VISUAL IMPACT ASSESSMENT

OBJECTION TO DEVELOPMENT APPLICATION

33 CROSS STREET, DOUBLE BAY

MARCH 14 2025

Existing site photo - Unit 703, No.349, New South Head Road

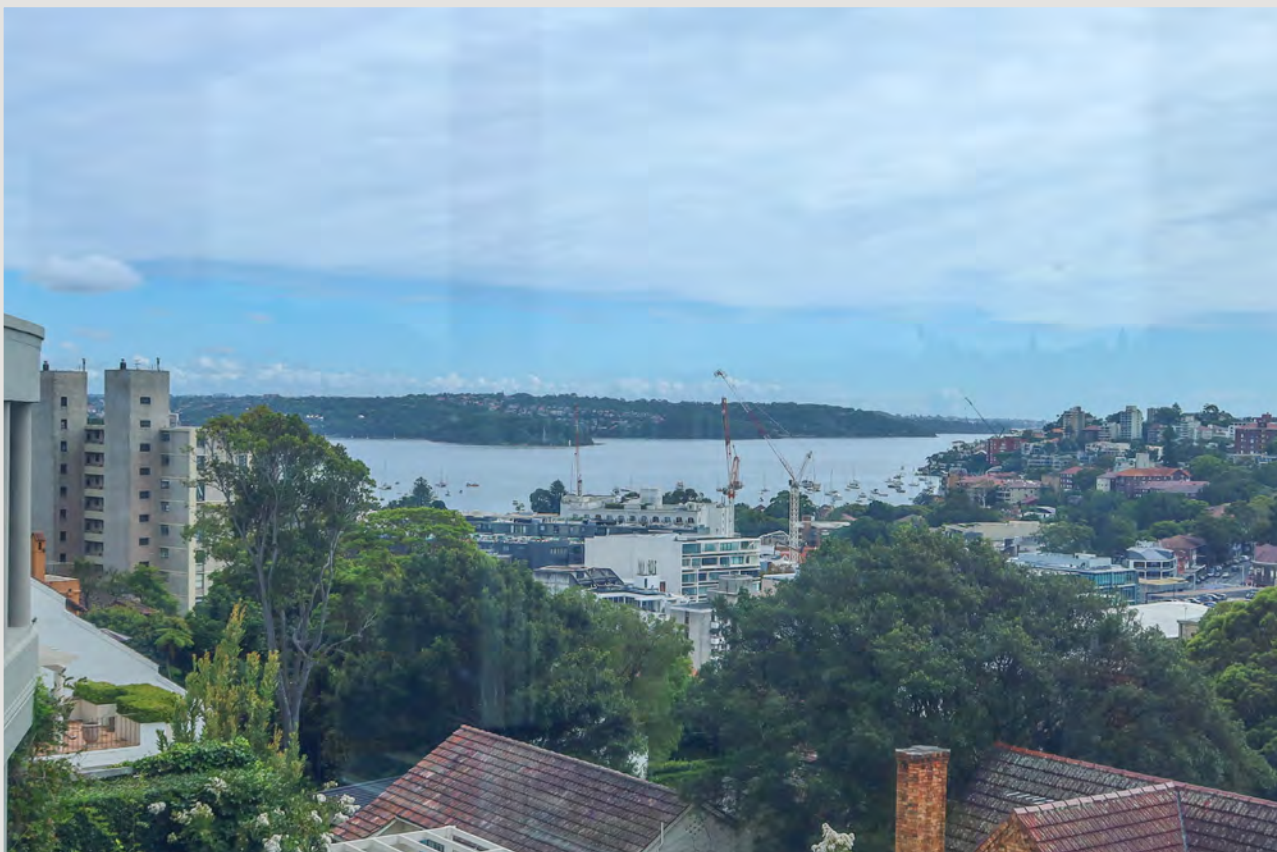
This is a static, private view from the level 7 external balcony of Unit 703, No.349, New South Head Road, 1m from the balustrade line, at standing height, looking towards the site to the northeast. From this location, the subject site is observed in the mid-ground, beyond various residential and commercial rooftops, to the water of Double Bay and the foreshore of Blackburn Cove to the northeast. Beyond Port Jackson, to the north, the land/water interface at Bradley's Head, Taylor's Bay Reserve and Georges Head is seen, progressing to the east. Further, Middle Head and Manly are seen. The foreshore of Blackburn Cove and the rising topography of the Point Piper Headland are visible, without obstruction. To the east, the rising topography of Point Piper Headland and ridgeline are clearly visible.

The visual impact of the new proposal relates to the bulk and scale of the development, within the context of the surrounding urban fabric, in addition to the view loss, which consists of a significant portion of the water view to the north-northeast and the foreshore around Blackburn Cove. When reviewed against the scale of this view's extent, the visual impact would be assessed as Severe.

Reasonableness of proposal: The new proposal creates view loss to the highest-value component of the view from this property, being the Blackburn Cove harbour foreshore. The proposal's non-compliance with the permissible height limit for the site is the cause of the visual impact, which is classed as Severe within the Tenacity Assessment Scale. This is not considered a reasonable, or acceptable, proposal within this context.

Existing site photo - No.331, Edgecliff Road

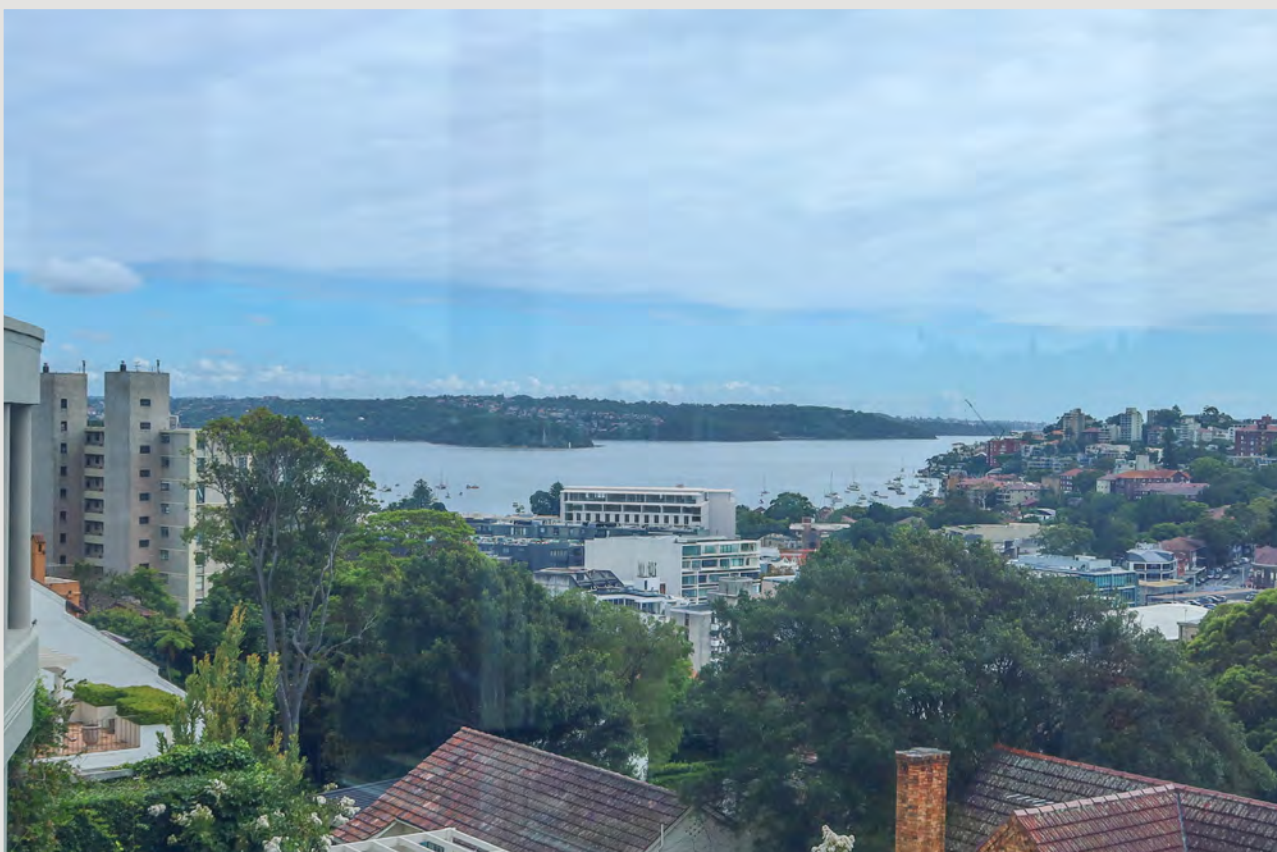
This is a static and private view from the first floor study window of the residential property at No.331, Edgecliff Rd, gazing north-east, 1 metre away from the gazing and standing height, looking north-northeast towards the subject site. The foreground views to the north are partially obscured by the adjoining dwelling at no.333 Edgecliff Rd. As the view moves eastward, other one and two-storey residential buildings are observed across the descending topography. The midground perspective to the east is partially obscured by mature trees bordering the residential dwellings. The subject site is observed in the mid-ground, beyond various residential and commercial rooftops, to the water of Double Bay and the foreshore of Blackburn Cove to the northeast. Beyond Port Jackson, to the north, the land/water interface at Bradley's Head, Taylor's Bay Reserve and Georges Head is seen, progressing to the east. Further, Middle Head and Manly are seen. The foreshore of Blackburn Cove and the rising topography of the Point Piper Headland are visible, without obstruction. The visual impact of the new proposal relates to the bulk and scale of the development, within the context of the surrounding urban fabric, in addition to the view loss, which consists of a moderate amount of the water view to the north-northeast and the foreshore trees. When reviewed against the scale of this view's extent, the visual impact would be assessed as Minor-to-Moderate.

Reasonableness of proposal: The new proposal creates view loss to the Double Bay water view. The proposal's non-compliance with the permissible height limit for the site is the cause of the visual impact, which is classed as Minor-to-Moderate within the Tenacity Assessment Scale. This is not considered a reasonable, or acceptable, proposal within this context.
